Attachment N

Development and Application of an Instream Flow Assessment
Framework for the Fountain Darter (*Etheostoma fonticola*)
and Texas Wild-Rice (*Zizania texana*) in Spring
Lake and the San Marcos River System

August 2, 2004

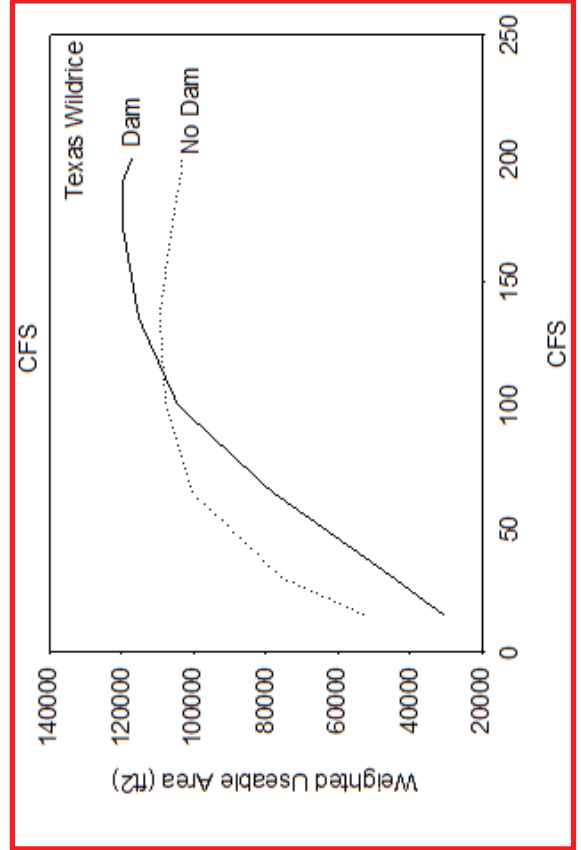
This graph (left) was produced based upon the data shown in Table 1 (above) and graphically displays what the numbers show: Texas Wild Rice has a higher WUA (Weighted Usable Area) with Cape's Dam in place.

An examination of Hardy's data, and this graph produced from Hardy's data, demonstrates rice habitat with a dam is favored at about 100 cfs or greater, which occurs about 90% of the time. Therefore Cape's Dam would provide *more* habitat for rice *more often* than the benefits of no dam during low flows, which occurs infrequently.

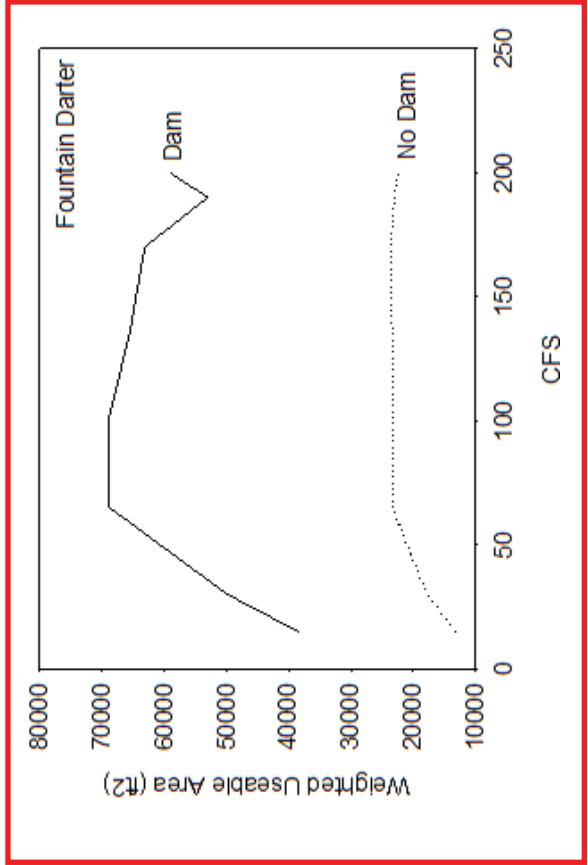
* How is the results presented to the City of San Marcos in Hardy's October 2015 report that there would be an increase in suitable habitat for Fountain Darter at all flow rates for all dam scenarios (full dam, half-dam, no dam), when this report, dated August 2004 shows a "quite dramatic" decrease in Fountain Darter habitat for all flow rates, without a dam? Please see Table 2 on page 12 of this report for data.

This graph (left) was produced based upon the data shown in Table 1 (above) and graphically displays what the numbers show: Fountain Darter has a substantially higher WUA (Weighted Usable Area) at ALL flow rates with Cape's Dam in place.
